# Metropolitan Development Commission Plat Committee (December 13, 2023) Meeting Agenda

**Date:** Wednesday, December 13, 2023    **Time:** 1:00 PM

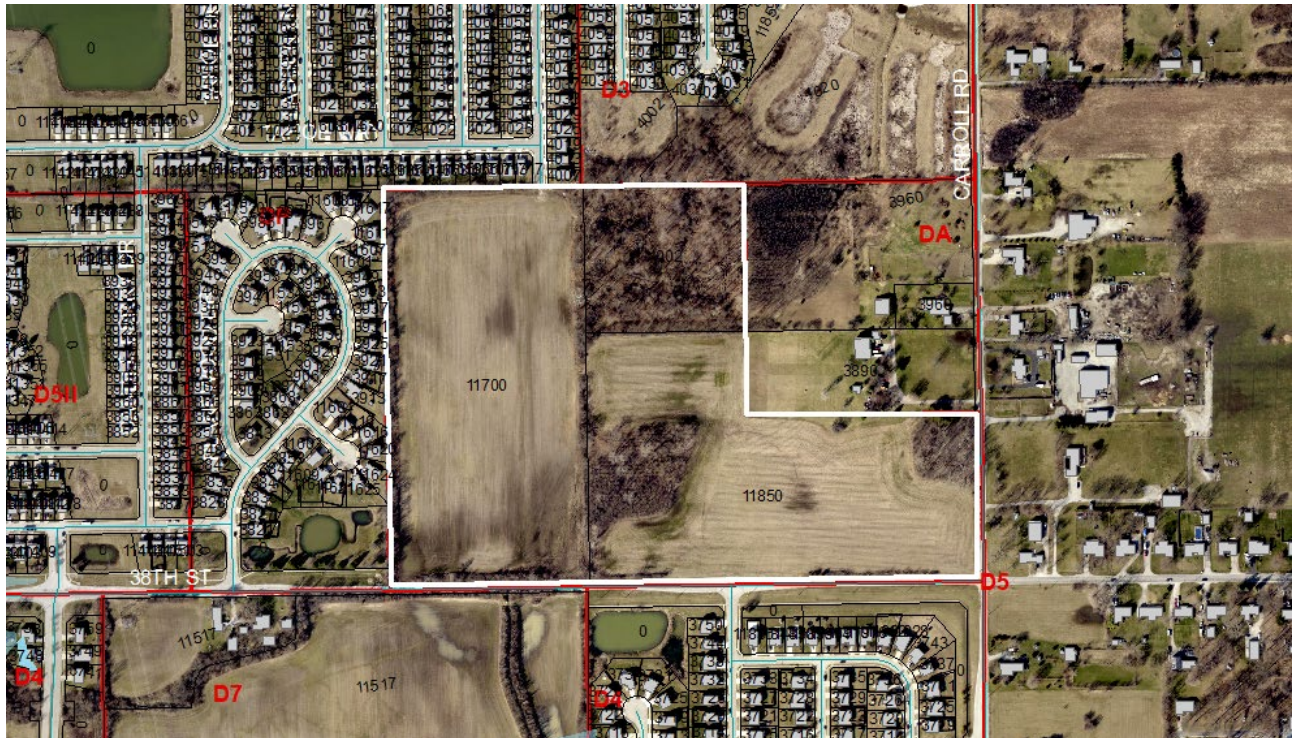
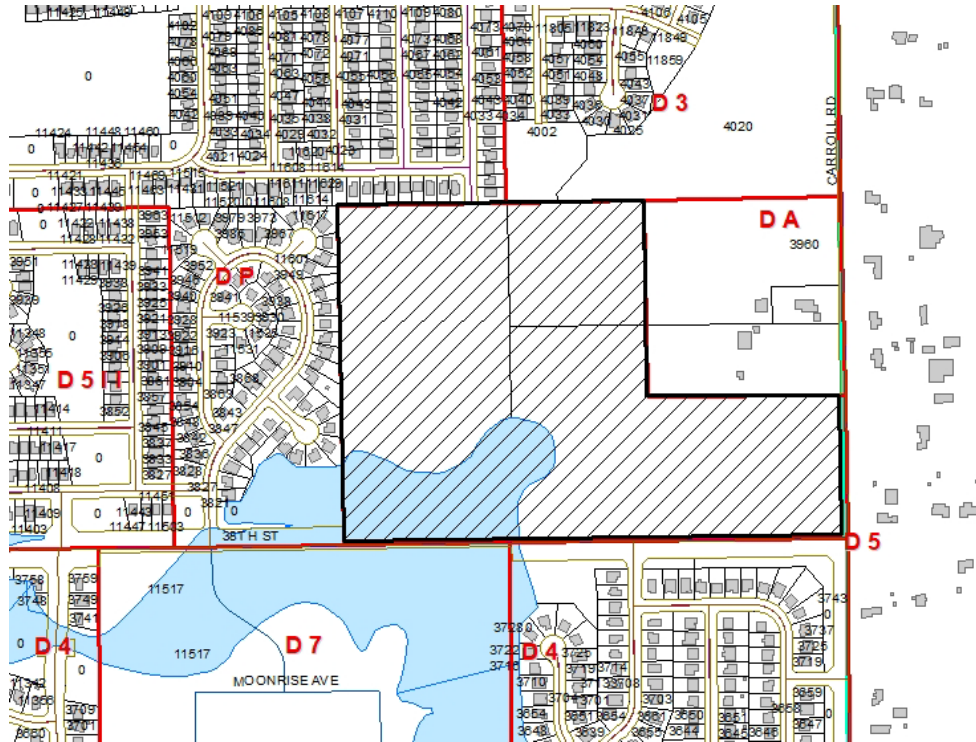
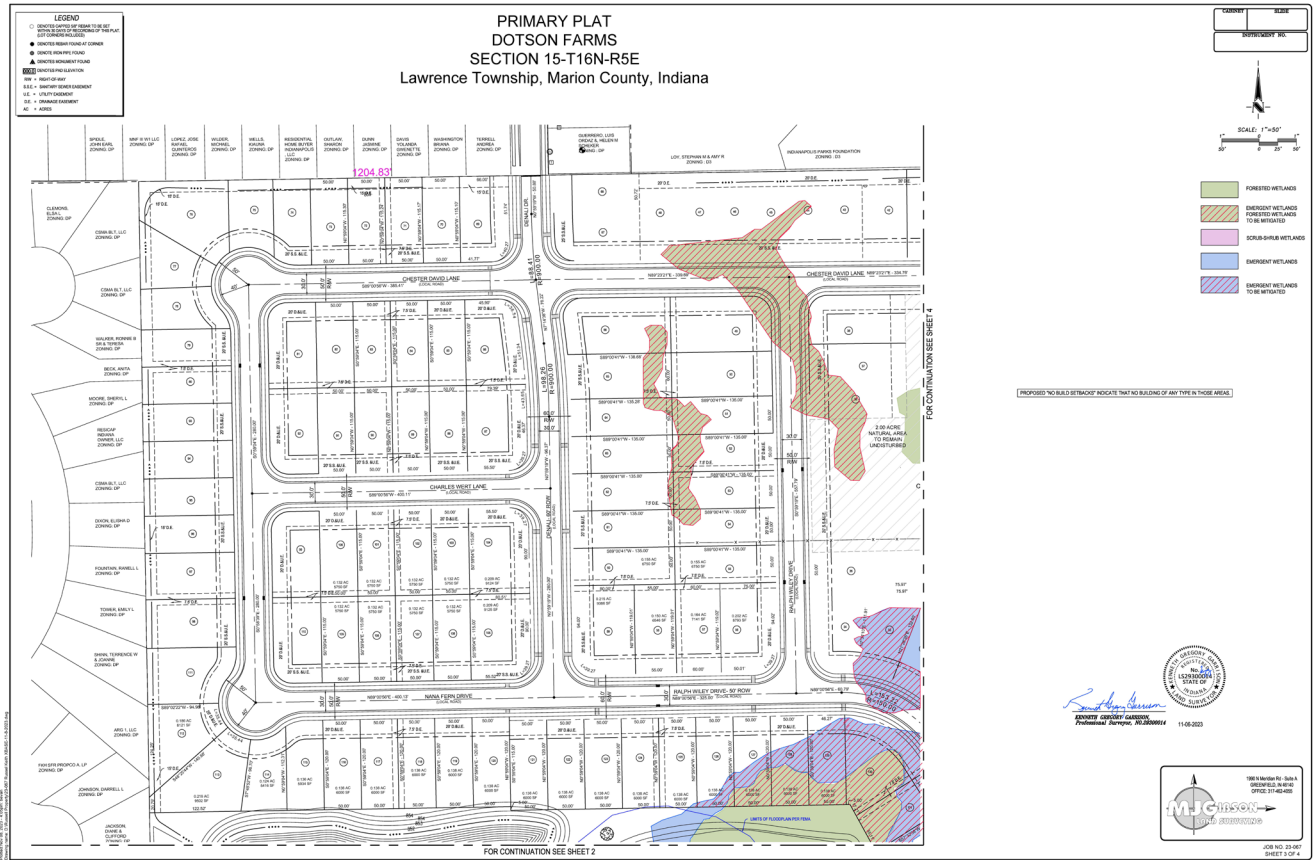
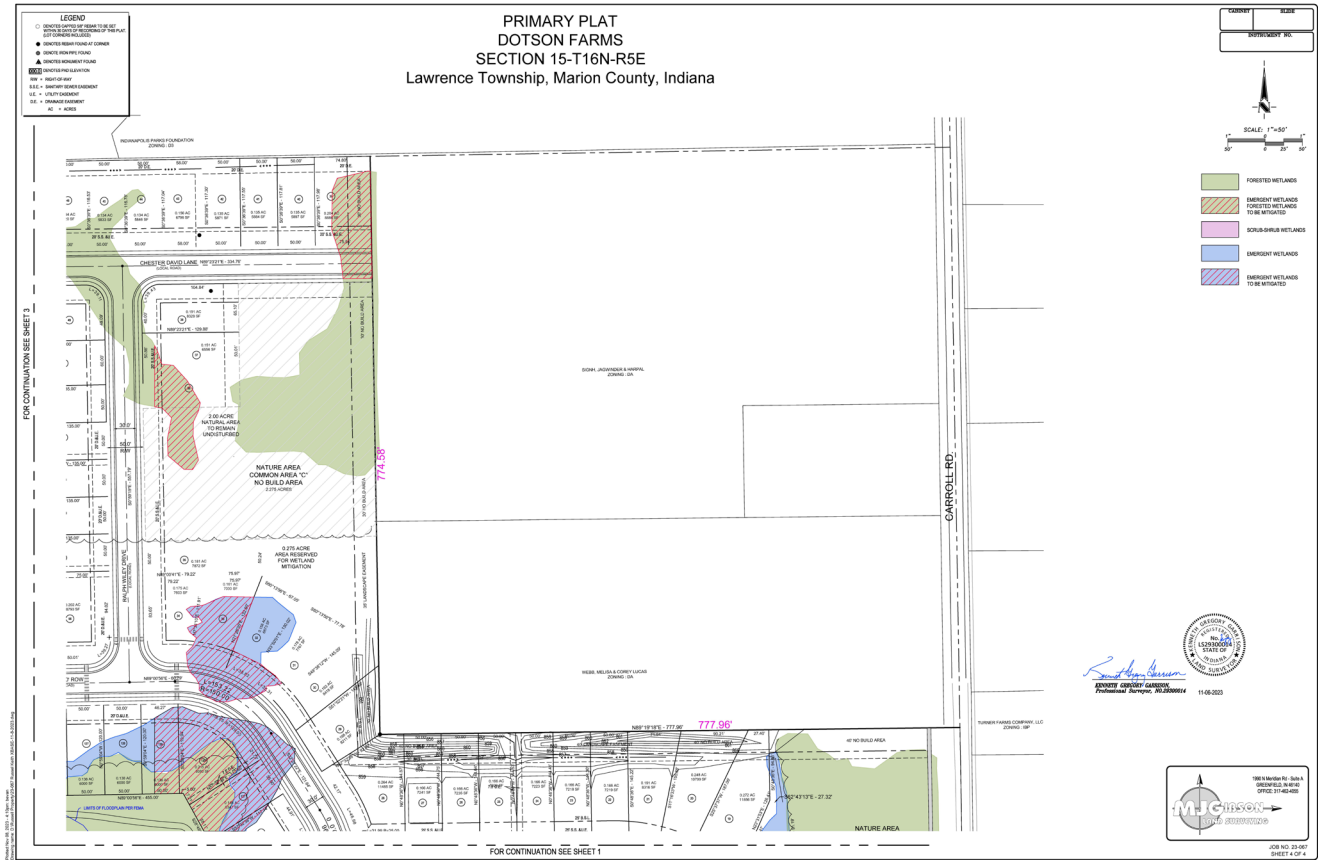
This petition was continued from October 11, 2023 to November 8, 2023 and from November 8, 2023 to December 13, 2023, at the request of staff, to allow time for the petitioner to correct issues with the plat.

12. That a dedicatory statement be included in the Owner's Certificate on the plat, prior to final plat recording.
13. That a statement be added to the plat that the "eyebrow" portion of the right-of-way be maintained by the Home Owner's Association. The eyebrow area shall be "hatched" or otherwise indicated on the plat and included in the key, prior to final plat recording.

17. That a revised Natural Infrastructure Plan be submitted for Administrator's Approval prior to final plat recording.
18. That a revised Traffic Control Plan be submitted for Administrator's Approval prior to final plat recording.

19. That a revised Tree Inventory/Preservation Plan be submitted for Administrator's Approval prior to any earth movement or tree removal.
20. That the dedication of right-of-way along both perimeter streets be revised to match the requirements of the zoning commitments.

21. That a lighting plan compliant with Section 744-600 of the Consolidated Zoning and Subdivision Ordinance be submitted prior to recording the final plat.

This request would provide for the subdivision of 46.2 acres into 138 lots, to be known as Dotson Farms. The subject site was rezoned to the D-5 classification in 2022 (2022-ZON-030). The most recent version of the plat reviewed by staff had numerous deficiencies. Therefore, staff has placed several conditions on the approval of the plat. If all of the

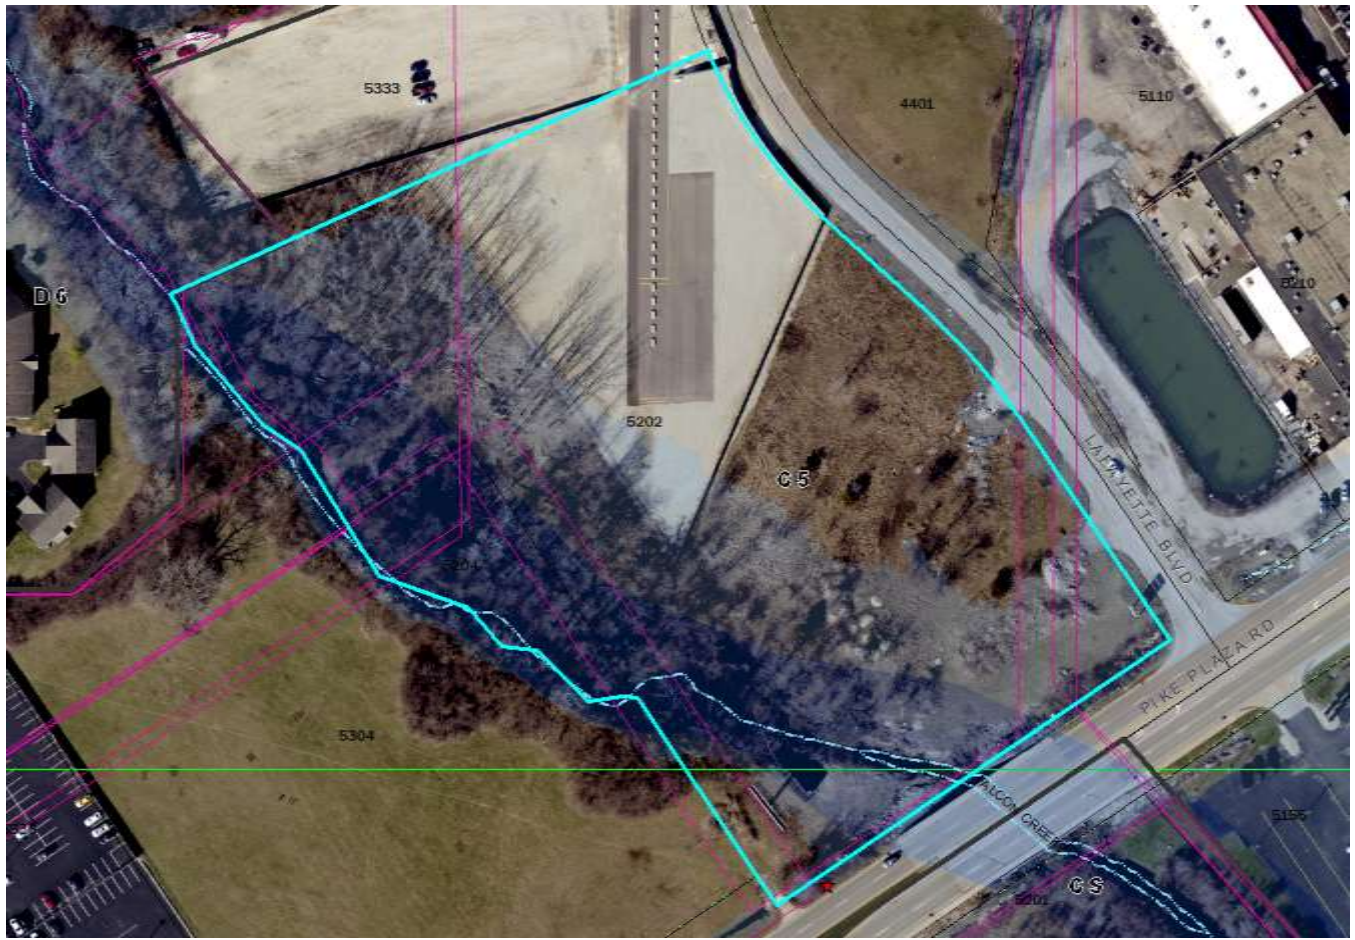
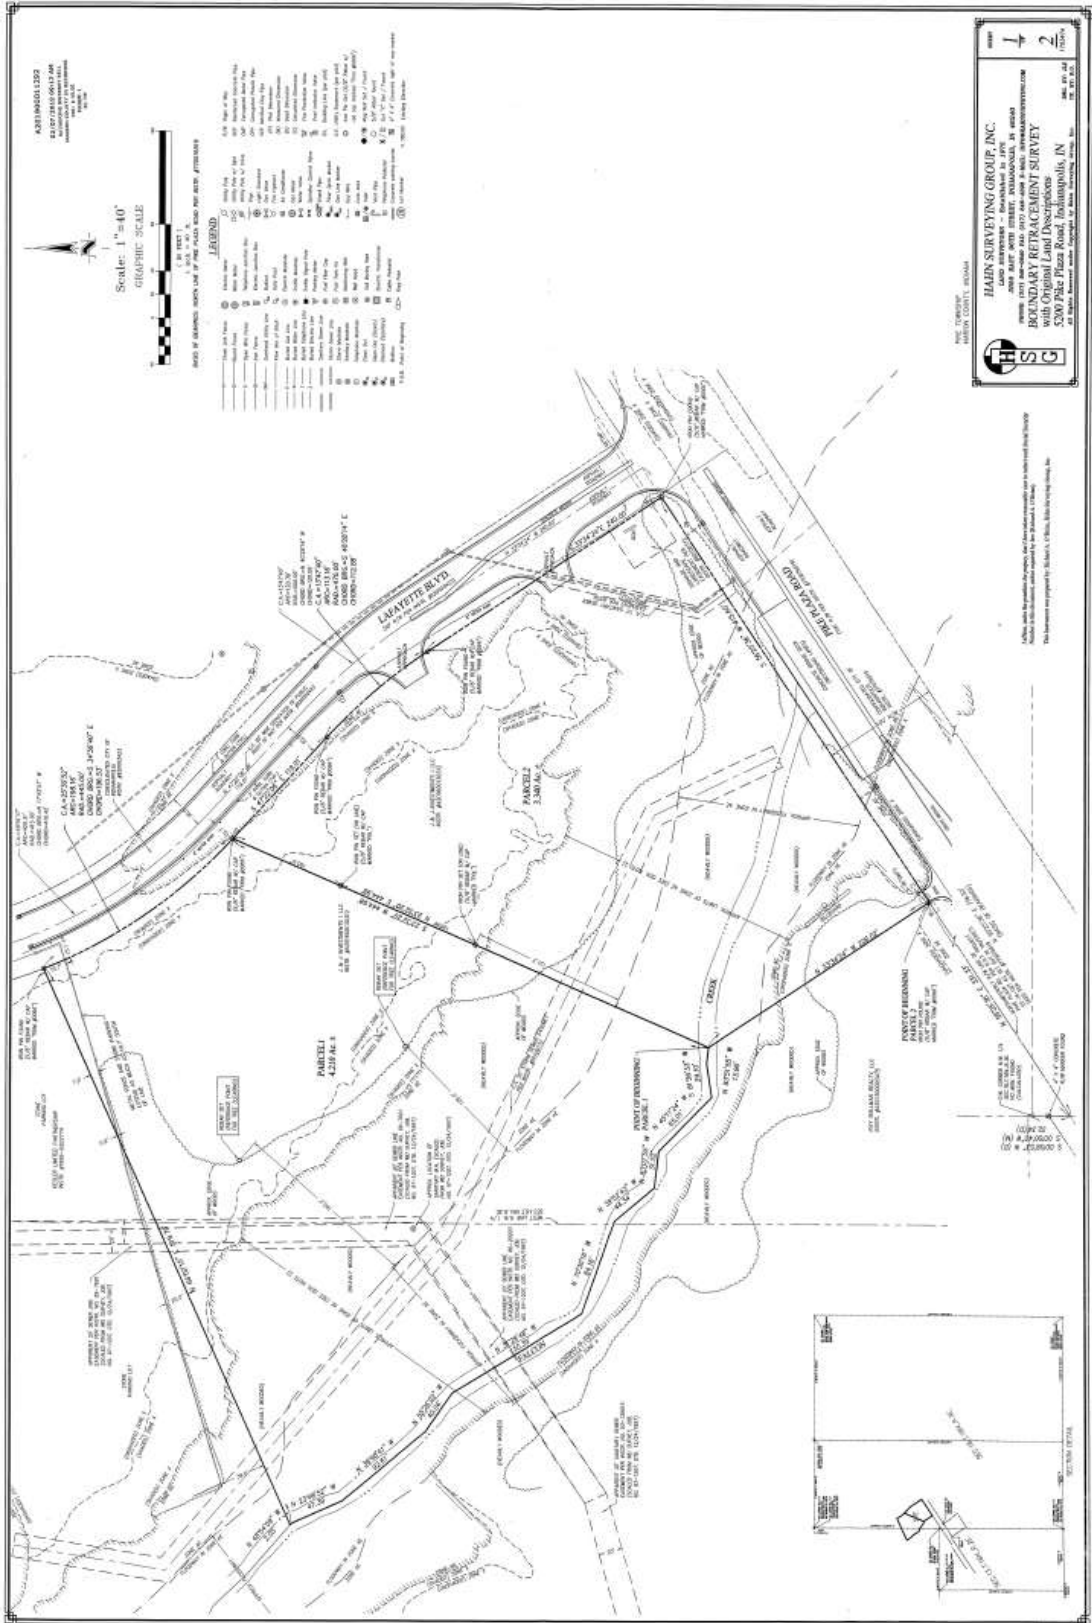
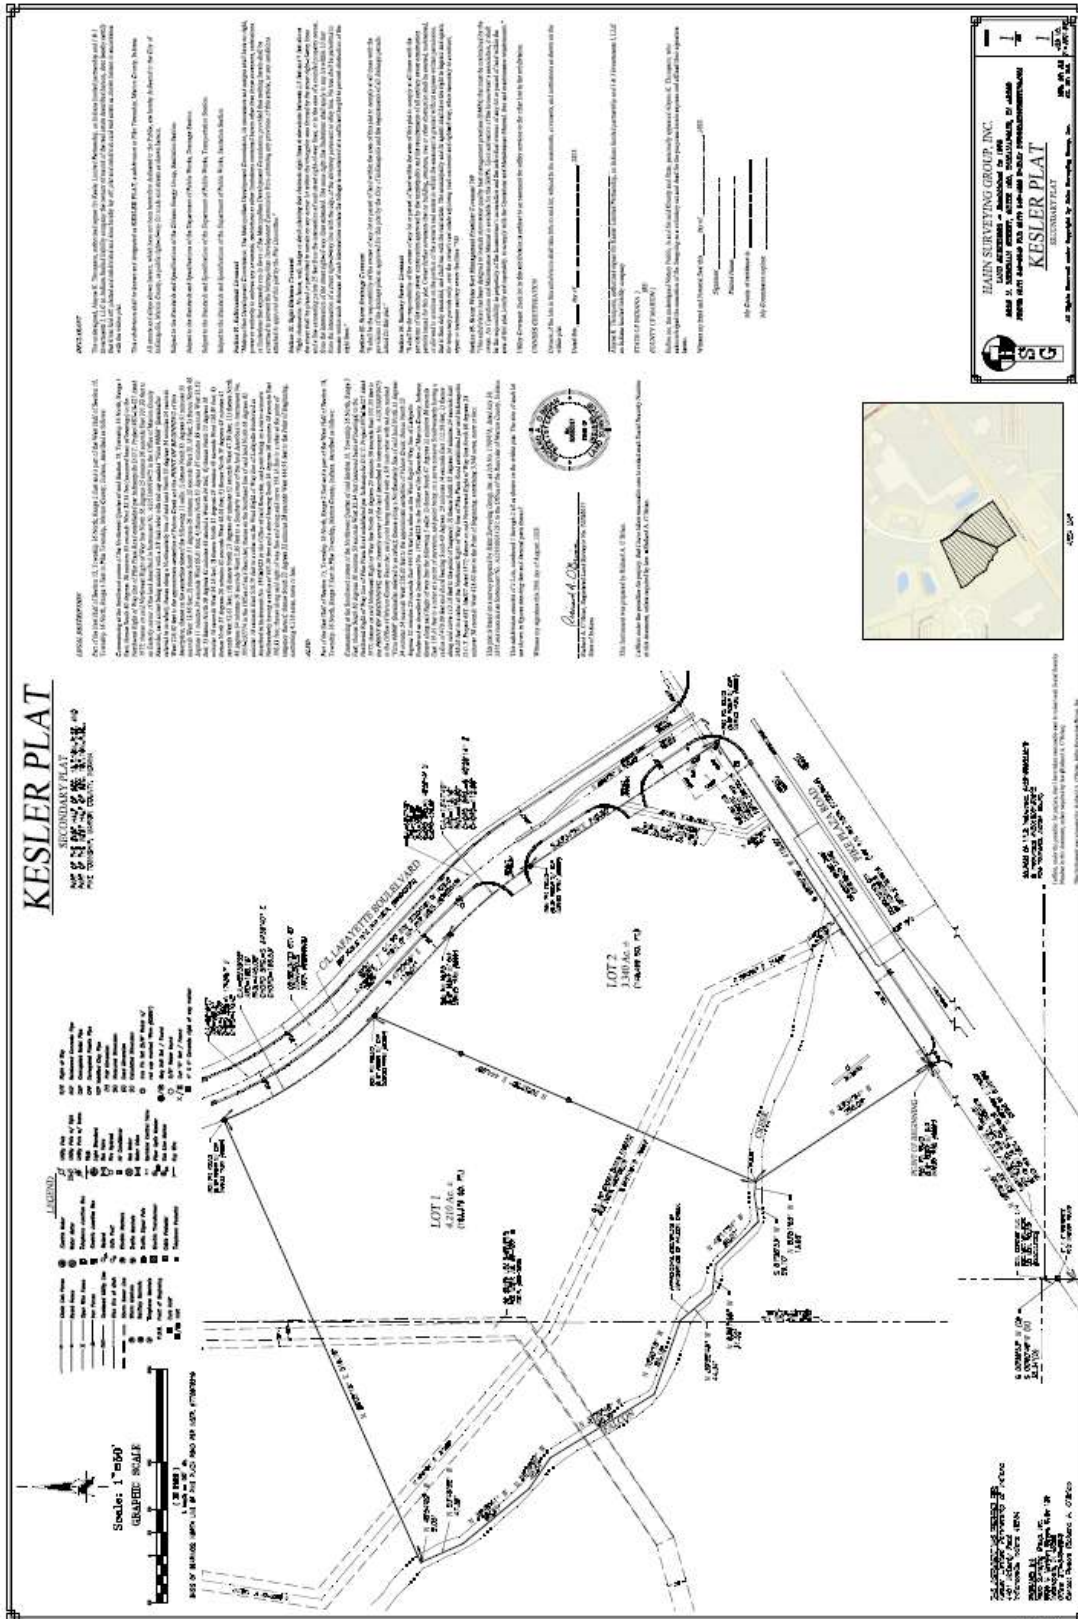
Sidewalks would be required to be installed along Pike Plaza Road and Lafayette Boulevard per the ordinance. There is a drainage ditch along Pike Plaza Road; however, there is a bridge including a sidewalk over Falcon Creek on the south frontage, which would suggest that installation of sidewalks is possible. There is also evidence of people walking on this frontage per the Google Street View image below, indicating that pedestrian infrastructure is needed. There are no topographic challenges for installing sidewalks along Lafayette Boulevard. Therefore, staff is recommending denial of the waiver.

If the plat committee approves the waiver against staff's recommendation, a contribution in lieu of sidewalk installation should be required as a condition of approval subject to Section 744-301.G.
